CONWAY HISTORIC DISTRICT COMMISSION MEETING

NOVEMBER 23, 2015 • 6:00PM • CITY HALL • 1201 OAK STREET

1A Calvary Church New Signage - 1832 Robinson Avenue

2A CASON & GRADY NEW OUTBUILDING - 1823 SCOTT STREET

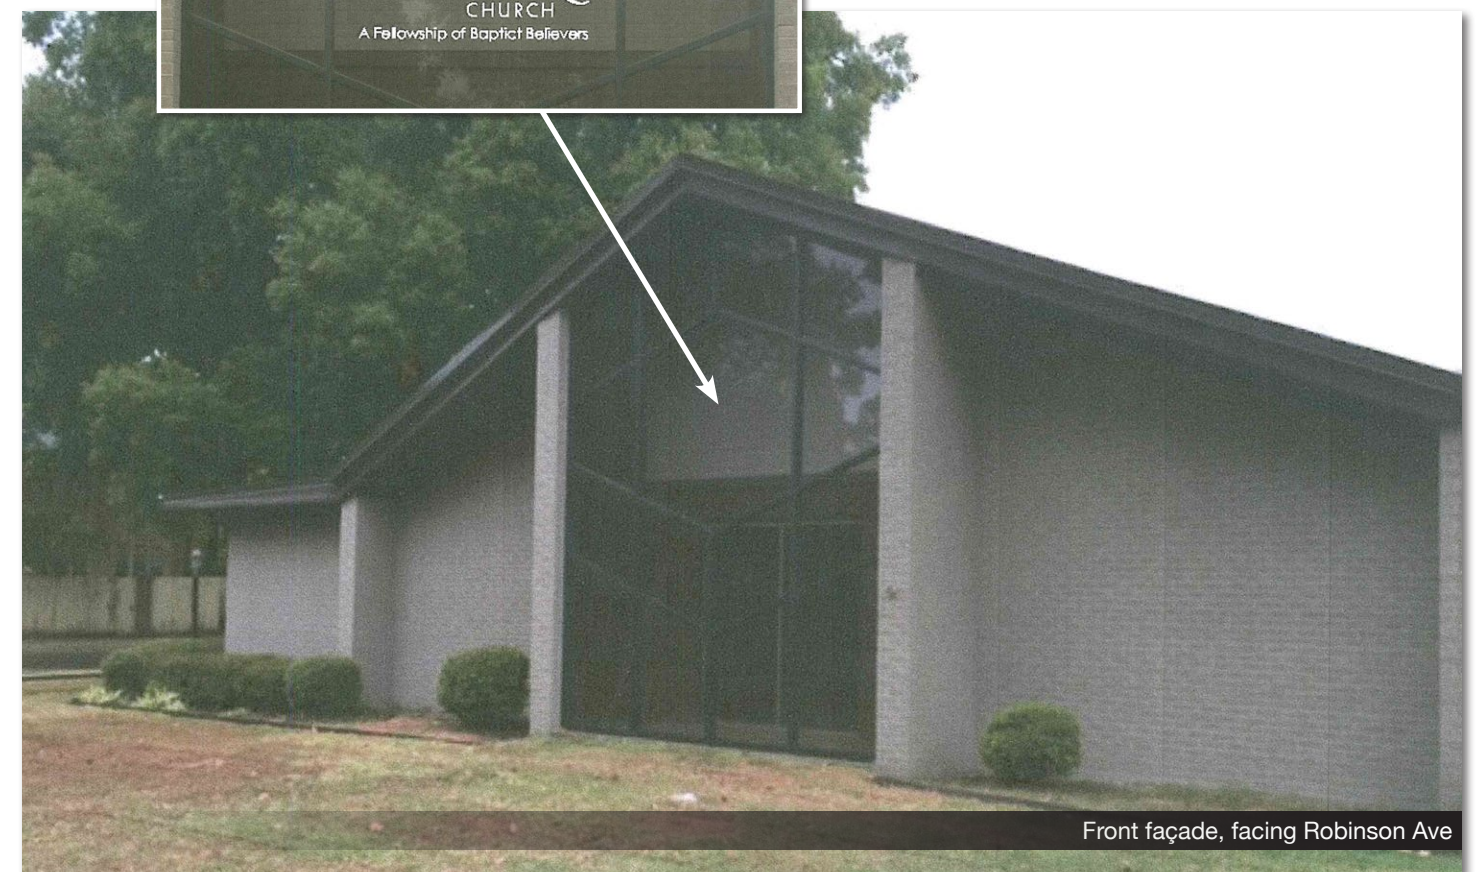
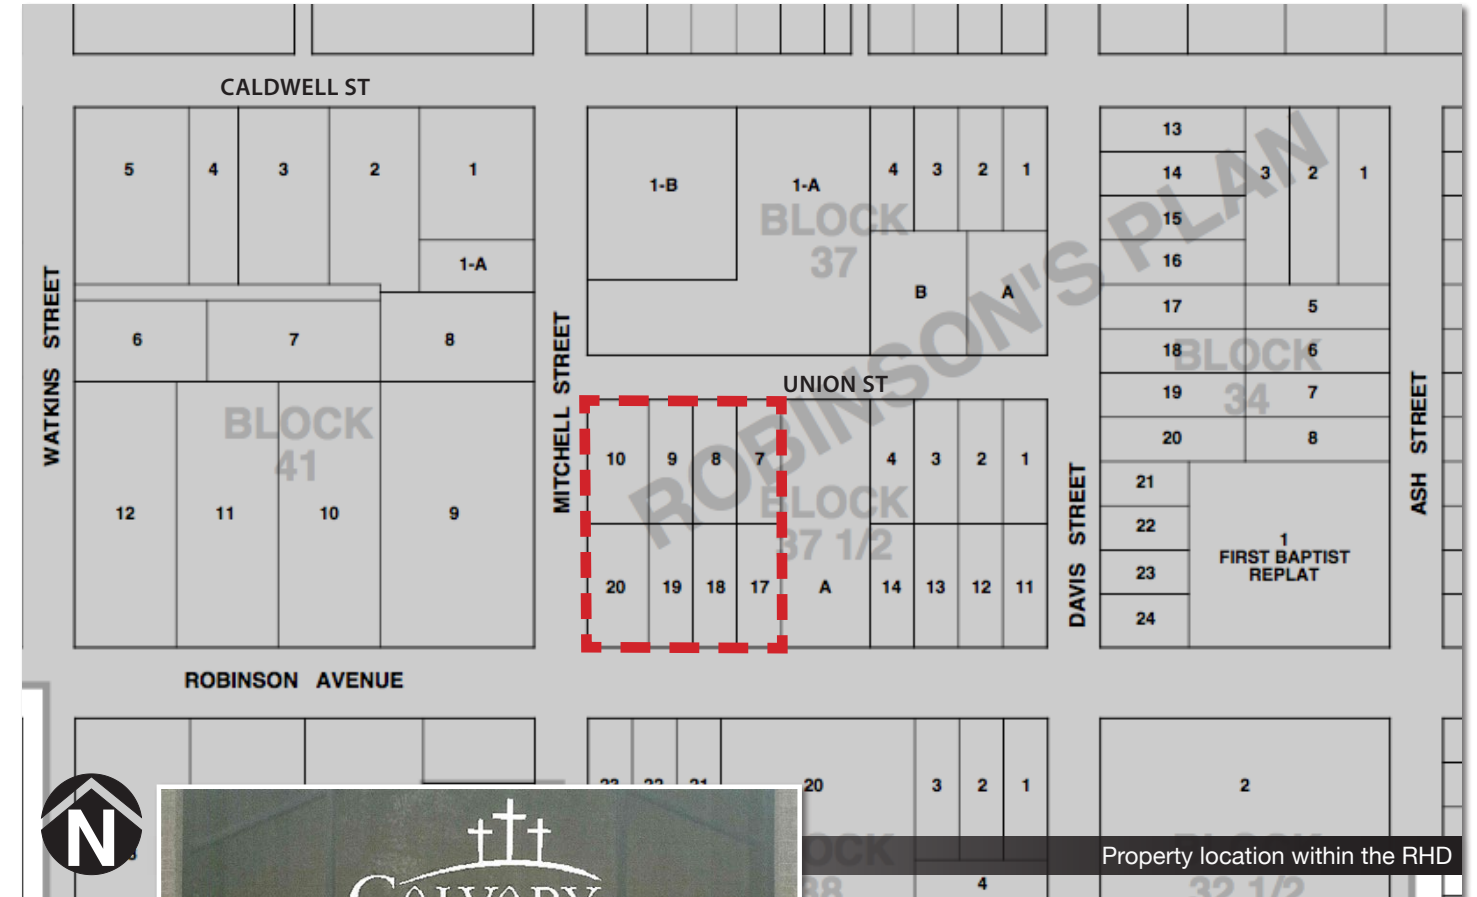
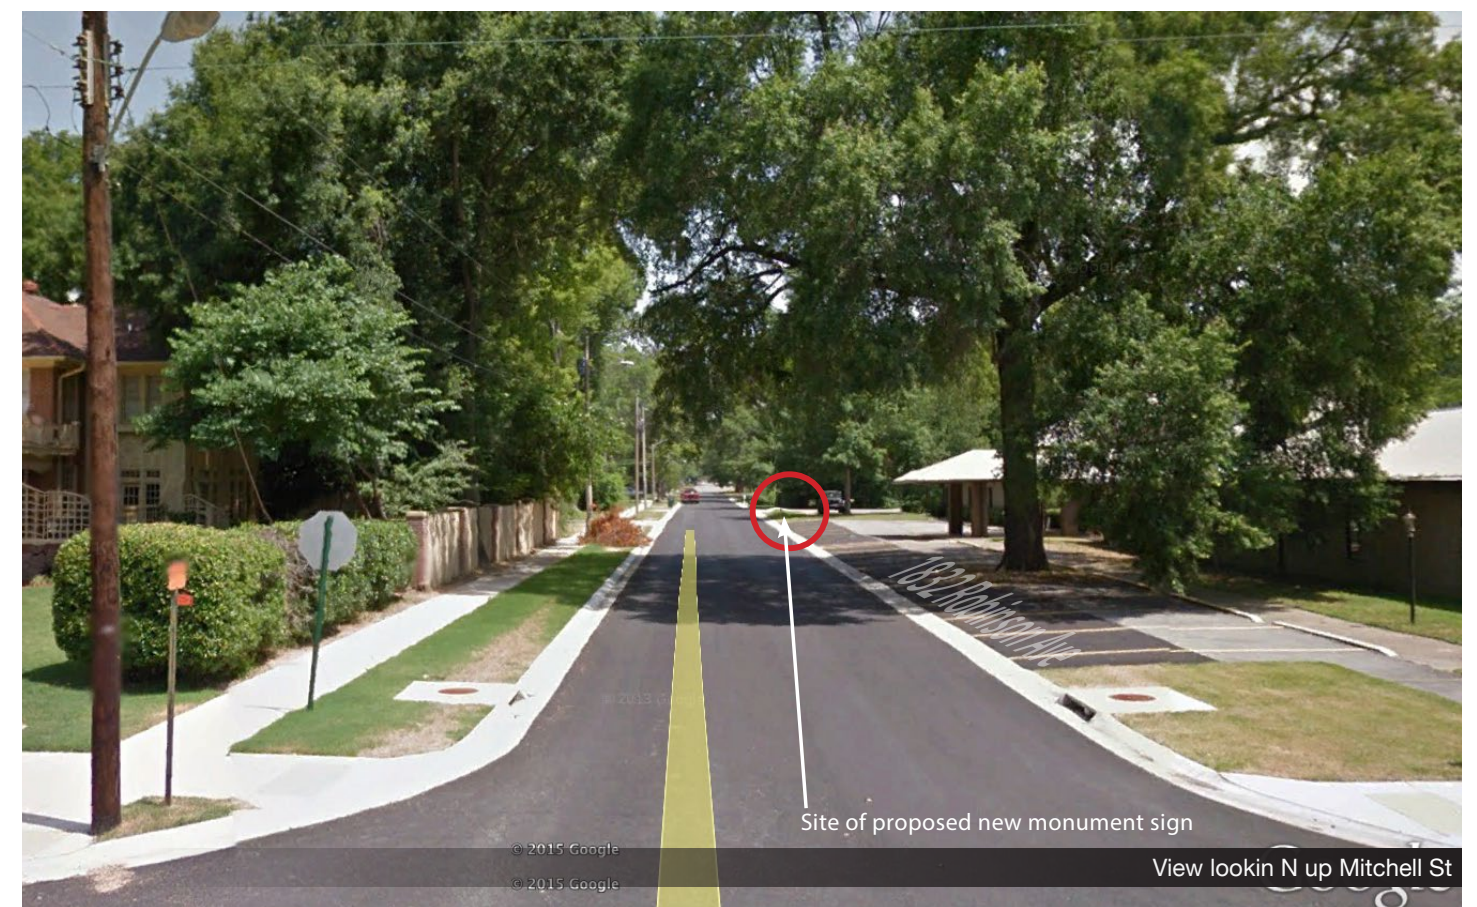
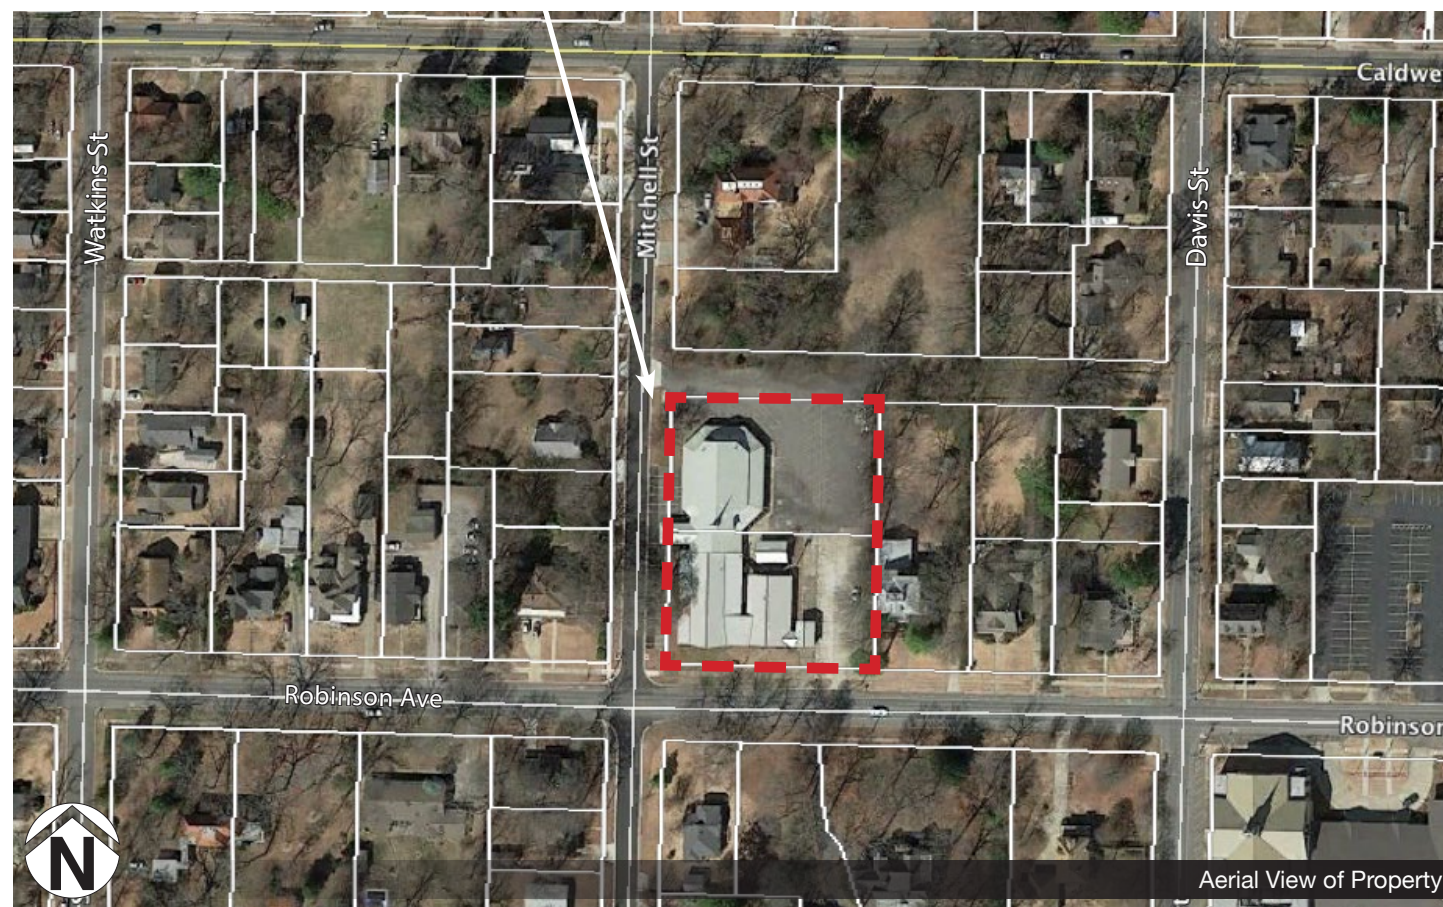
The window sign has a simple easy to read design and does not cover more than 25% of the window area. It is appropriate.

The free standing sign is constructed of traditional materials such as wood and is low to the ground. It is 16 square feet in area measured from the ground to top of sign and outside pole to outside pole. It is appropriate.

HDC Staff recommends approval of these signs as submitted.

Applicant provided proposed site plan

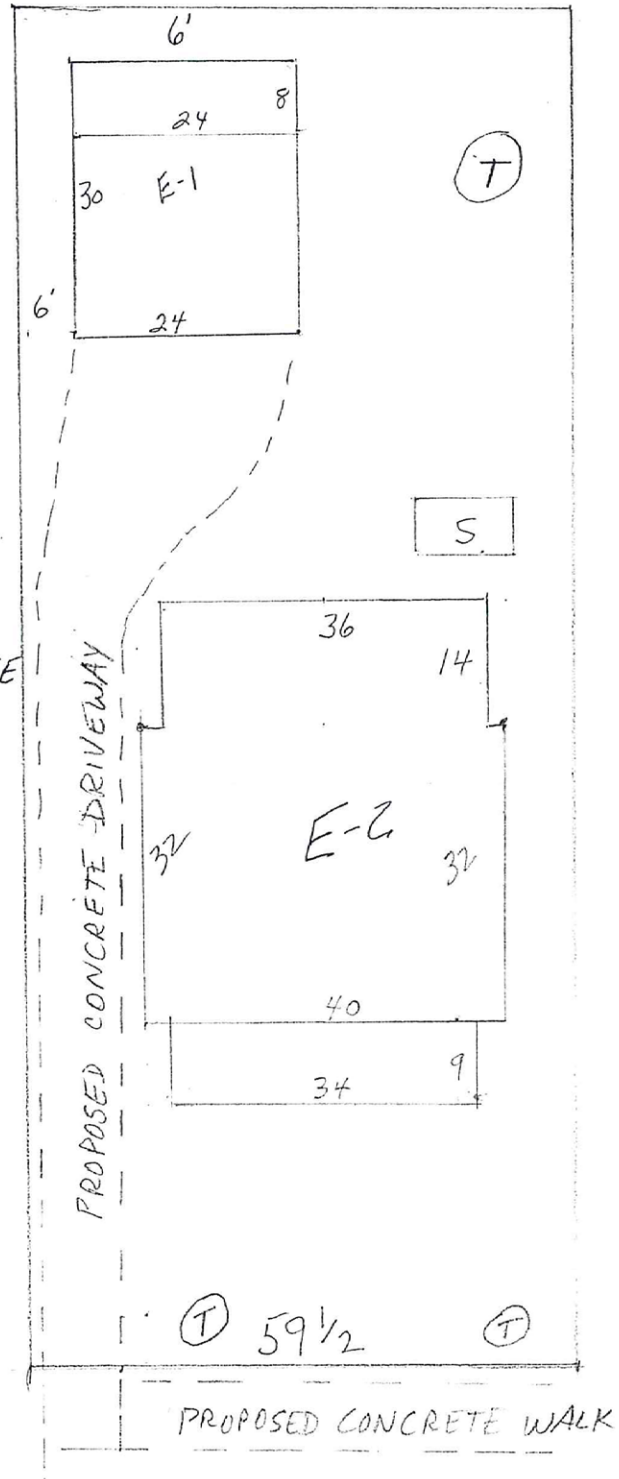
Setbacks. Proposed setbacks should respect the predominant setbacks of area structures, especially the front setback. Front setbacks are allowed within a range of 80% to 110% of the average area front setback. Front setback will not be applicable. An outbuilding is typically allowed with 5 foot side setbacks, however, 0 foot sides are common in the Old Conway area. Typical rear setback is 5 feet for an outbuilding. The proposed outbuilding setbacks are 6 feet on the rear and side. These setbacks are appropriate.

Driveway/Parking. A 10 foot wide concrete driveway is proposed along the east side of the lot from Scott Street to the garage/outbuilding. No more than 50% of the front yard may be paved for parking. The proposed driveway is appropriate.

Footprint. The area of land covered by a structure should be in relation to the majority of neighboring structures. The outbuilding's footprint is 720 s.f. The residence is 2000 s.f. Old Conway guidelines state that an outbuilding should not be larger than 30% of the residence. By this guideline, the requested outbuilding is 120 s.f. oversized. However, the lot is large compared to the average Old Conway lot. It would seem appropriate to allow the additional 120 s.f. Construction of an outbuilding larger than 30% of the residence also trigger sidewalk construction/reconstruction. A new sidewalk is proposed.

Architectural Details, Siding, and Bricks. Eaves, brackets, dentils, cornices, molding, columns, trim, etc. The residence has minimal details accomplished through wide wood moulding. The outbuilding openings could use wider trim boards to better match the residence.

1. The outbuilding shall be constructed as shown in submitted plans.
2. Driveway shall be concrete and may be a "ribbon" driveway.
3. The outbuilding rear and side setbacks shall be approximately 6 feet.
4. Trim around doors shall be wide to match the existing residence.
5. The outbuilding shall be allowed with a 720 square feet maximum footprint.

Proposed design options

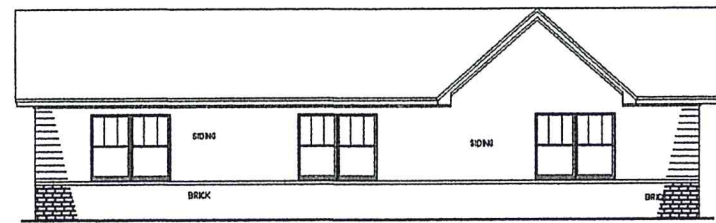
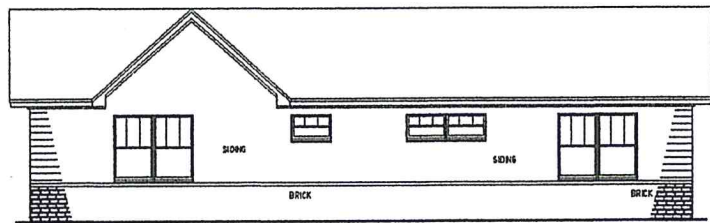
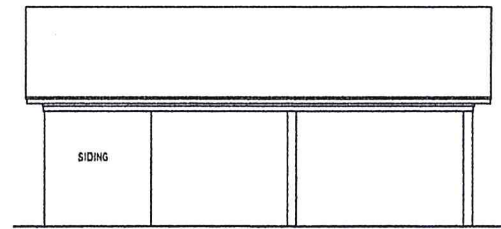
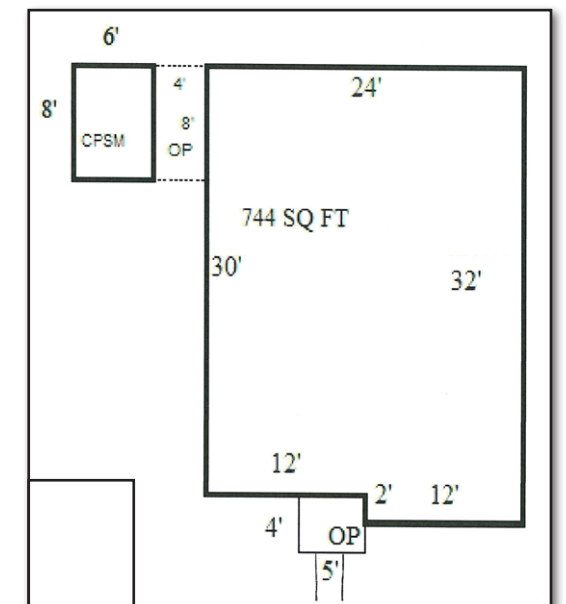
Complexity of form. The level of detailing and breaks in wall planes of a structure. The residence has minimal detailing accomplished with wide window and door trim. The residence's wall planes are broken by a gabled front façade with a small gabled portico. There are also gables on the sides. The proposed rear addition would not affect the complexity of form. The applicant has proposed two possible front facades. Elevation A would change the current front to a new, more flat appearance by creating a new wide gable. Elevation B also pushes the double window wall forward, but adds a low angled roof to cover the porch area.

Entries, Porches, and Porticos. Appropriate entry points are provided. Porches are to be a minimum of 6 feet in depth. The front porch shown is small, but 6 feet in depth. Columns width should have a solid appearance.

Doors and windows. The front door is shown as a solid panel door. Rear doors are shown as full glass patio doors and a 1/2 light door. Windows are shown with 3 lights over one in a craftsman style. The original craftsman style windows seem to be intact. These should remain if possible. Smaller matching privacy windows are shown on the right elevation for bathrooms.

Architectural Details, Siding, and Bricks. Eaves, brackets, dentils, cornices, molding, columns, trim, etc. The existing residence has minimal details accomplished through wide door and window trim and decorative "pork chop" eave returns. These details should be retained. The original wood siding appears to be in place. The applicant would like to add a brick band around the lower bout of the house and replace the wooden siding with a vinyl or similar wood shake siding above. The applicant has included a photo of 1833 Johnston with a similar facade treatment.

1. The residence shall be constructed as shown in submitted plans. Or modified as prescribed by the HDC.
2. Driveway shall be concrete.
3. The residence's front setback shall be approximately 16 feet from the front property line. Outbuilding setbacks shall be approximately five (5) feet from the south property line and fifteen (*15) feet from the east property line.

4. Original windows should be preserved and reused as much as possible. External or internal storm windows are allowed.
5. Porch columns shall be a trimmed out to approximately eight (8) inches by eight (8) inches.

6. The two significant trees as shown shall be preserved.
7. Siding materials as used at 1833 Johnston shall be used.
8. HVAC and utility equipment shall be appropriately located at the rear or side of the structure and/or appropriately screened.

9. A four (4) foot sidewalk shall be constructed along Mitchell Street.
